Subject: Fuel Leak Case No. RO0000445

Former Mobil Station 99105, 6301 San Pablo Avenue, Oakland, California

### Work Plan Addendum

# Former Mobil Station 99105 6301 San Pablo Avenue Oakland, California

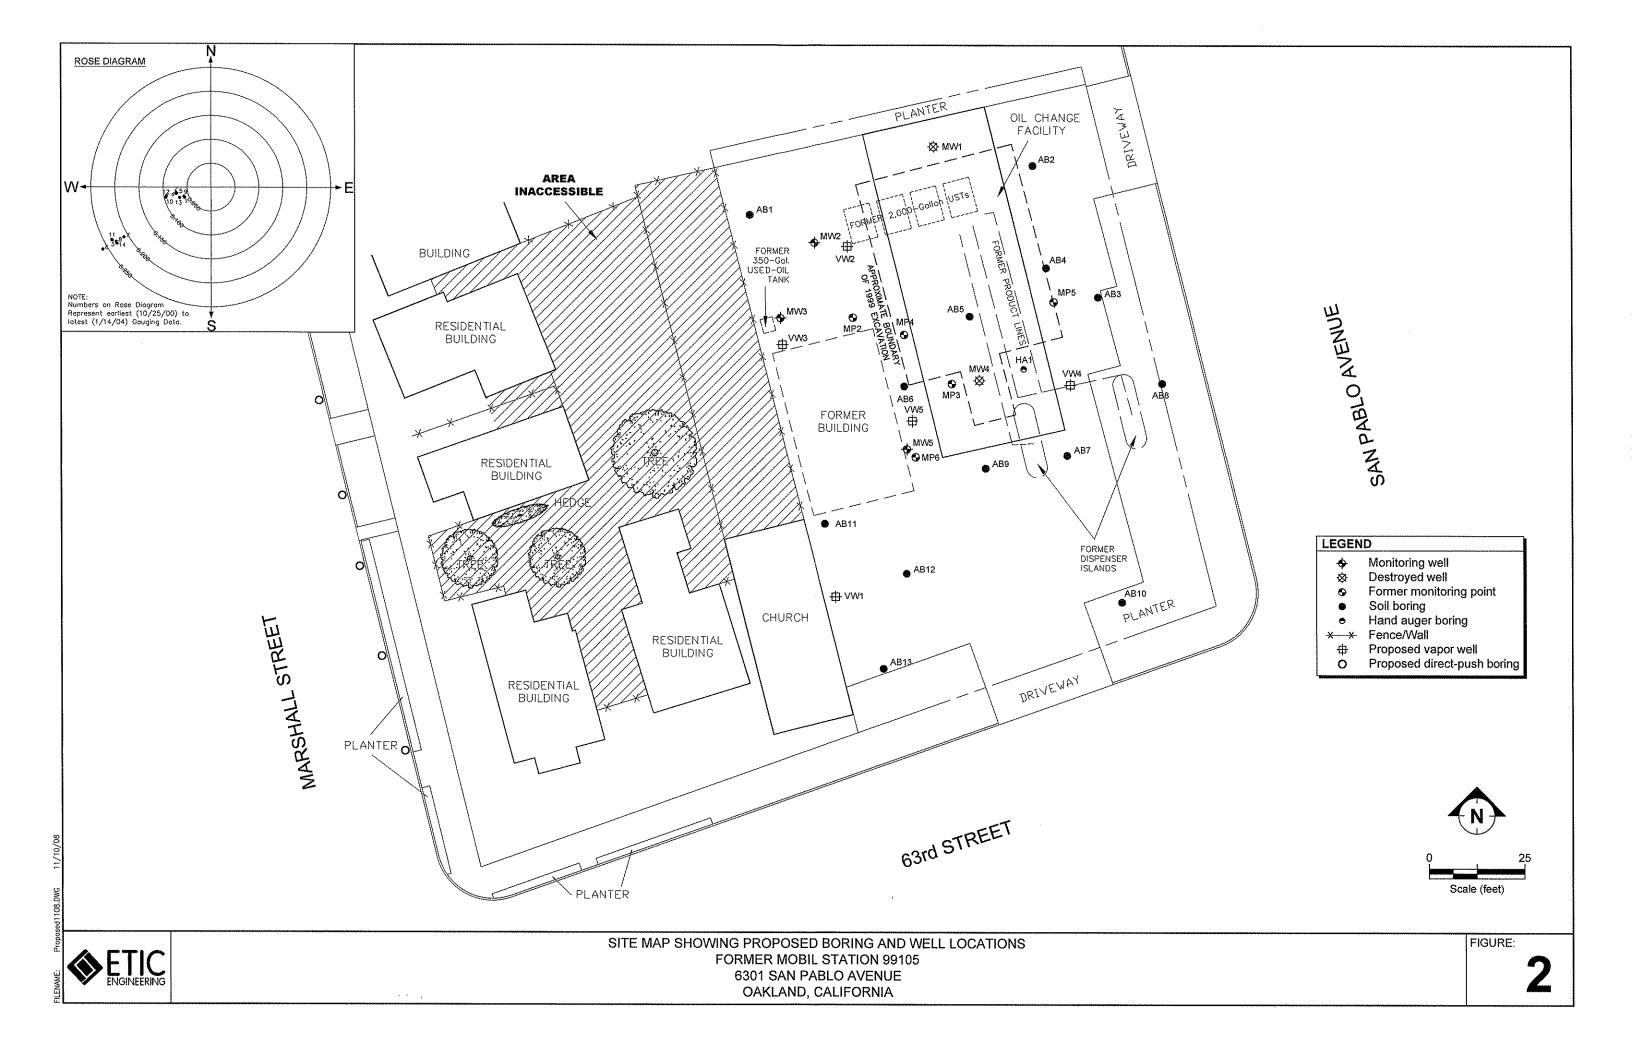
- Dissolved Groundwater Plume Characterization The proposed well is located approximately 145 feet away from MW-5 in what appears to be the cross-gradient direction. ACEH requested evaluation of the extent of the petroleum hydrocarbon plume at the adjacent property. Rather than install a permanent monitoring point that may not be downgradient of wells MW-5 and MW-3; we recommend that you utilize direct push technology to collect soil samples and depth discrete groundwater samples at multiple locations downgradient of wells MW-5 and MW-3. We recommend that your investigation incorporate expedited site assessment techniques. Expedited site assessment tools and methods are a scientifically valid and cost-effective approach to fully define the three-dimensional extent of the plume. Technical protocol for expedited site assessments are provided in the U.S. Environmental Protection Agency's (EPA's) "Expedited Site Assessment Tools for Underground Storage Tank Sites: A Guide for Regulators" (EPA 510-B-97-001), dated March 1997. Please present your proposal to evaluate the lateral extent of groundwater adjacent to the site in the work plan addendum requested below.

A soil and groundwater investigation is proposed to assess the extent of dissolved-phase hydrocarbons in the predominant downgradient direction of the site. The installation of borings on the offsite properties adjacent to the site was initially considered as requested by the ACHCSA. However, an evaluation of the offsite properties indicates that most of the adjacent property areas are inaccessible (Figure 2). As such, the borings are proposed on Marshall Avenue at the locations shown on Figure 2.
